Product Change Notification / NTDO-04TZHM142

CCB 4883 Final Notice: Qualification of CEL-8240 as a new mold compound for 2N700x, DNx5xxN3, LP0701N3, TxxxxxN3, VNxxxxxx and VPxxxxxx device families available in 3L TO-92 package assembled at CRTK assembly site.

Pre and Post Change Summary

Lead Frame Comparison

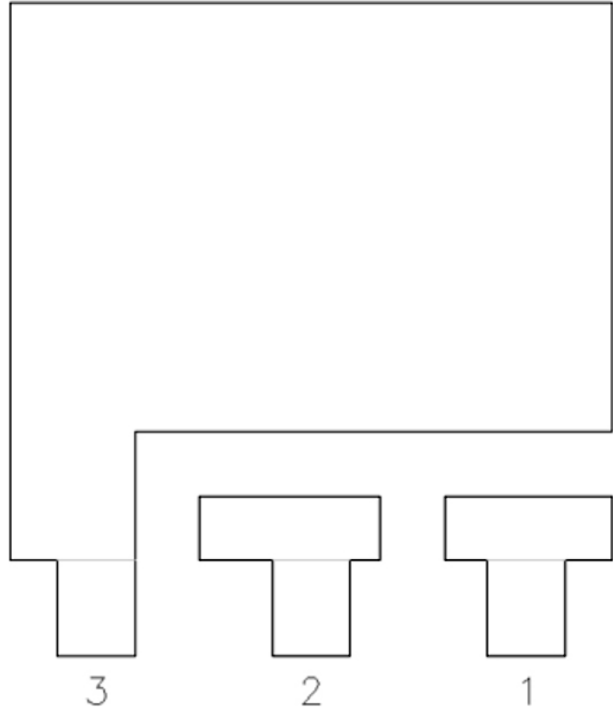
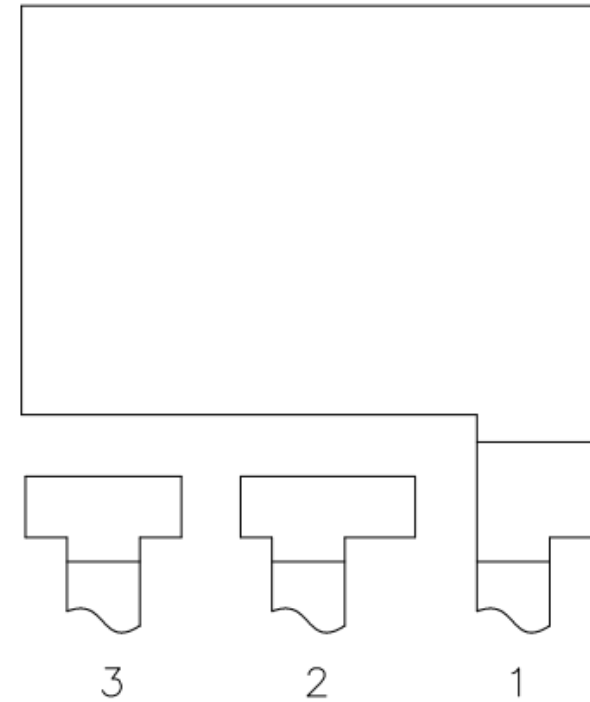
Lead Frame Material	CDA194 / A194
Lead-lock (Locking Holes)	No

Lead Frame Material*	A194
Lead-lock (Locking Holes)	No

Note:*C194, A194 or CDA194 Lead frame material are the same, it is just a MCHP internal labelling difference.

Package Layout

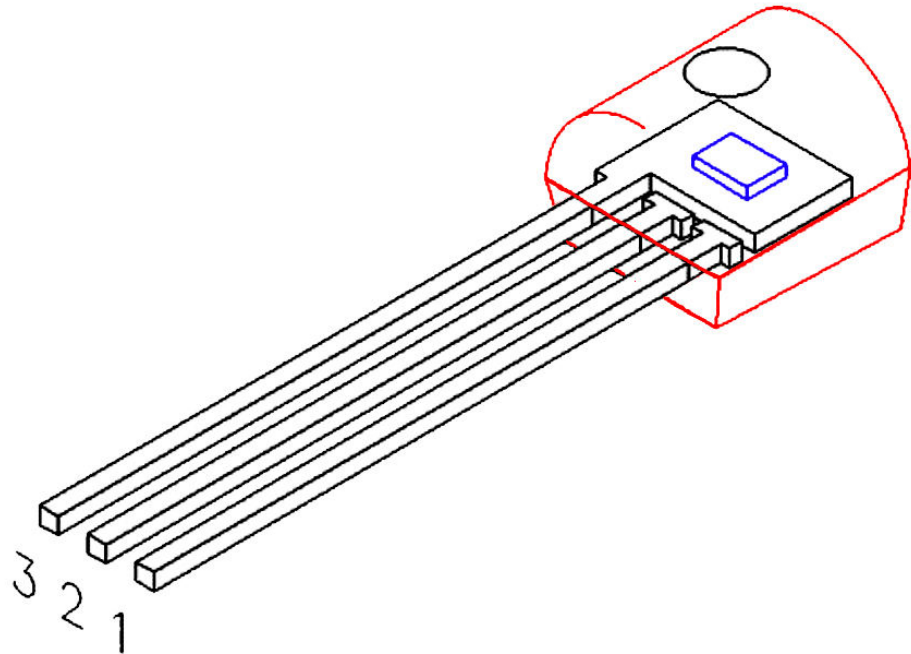
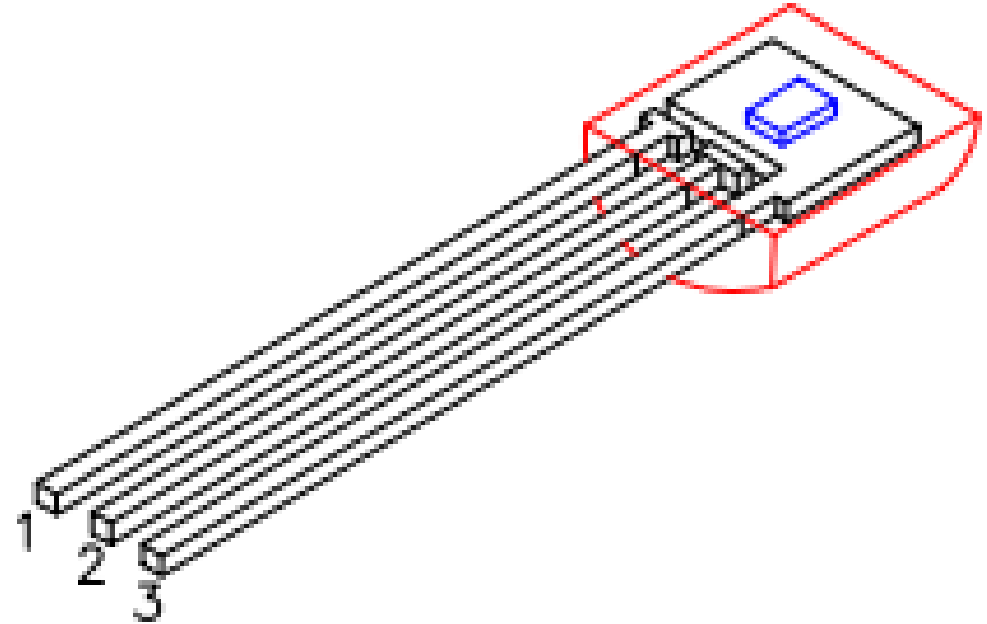
Die sit on flat side
